SUBJECT: Blurred copy problem on editor board

CLASSIFICATION:☒ Action Required☐ Trouble shooting☐ Retrofit Information☐ Revision of service manual☐ Information only☐ Other**MODEL:**

PDC-1E (Editor Board)

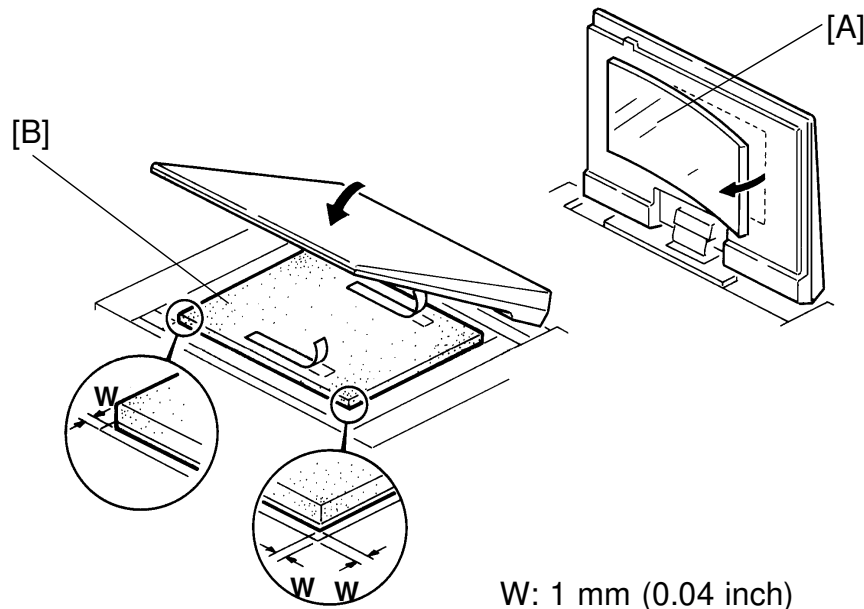
This problem occurs due to the deformed pressure pads (mirror surface). The deformed pad cannot press an original completely and there is a gap between the original and the exposure glass. The focal depth of the scanner is only 0.25mm. If this gap is 0.25mm or wider, an image in that part will be blurred.

The present pressure pad is made of polypropylen, which starts to deform from about 79°C (174.2°F) or higher. We suppose that the editor board suffers temperatures of 79°C or higher during transportation.

We have changed the material of the pressure pad from polypropylen to polycarbonate which does not deform at temperatures under 130°C (266°F).

Old Part Number	New Part Number	Description
A0491576	A0921594 This part number will be available as a service part in February 1994.	Original Pressure Pad

1. Remove the pressure pad [A] from the editor board.

2. Put the new pressure pad [B] as shown in the illustration.
Make a **1mm (0.04 inch)** space between the front scale and the front edge of the pressure pad, and between the right scale and the right side of the pressure pad.
3. Peel off the cover from the two adhesive tapes, close the editor board and press the editor board by hand. Especially, press the part directly above the tapes.
4. Confirm that there is no blurred image on the copy.
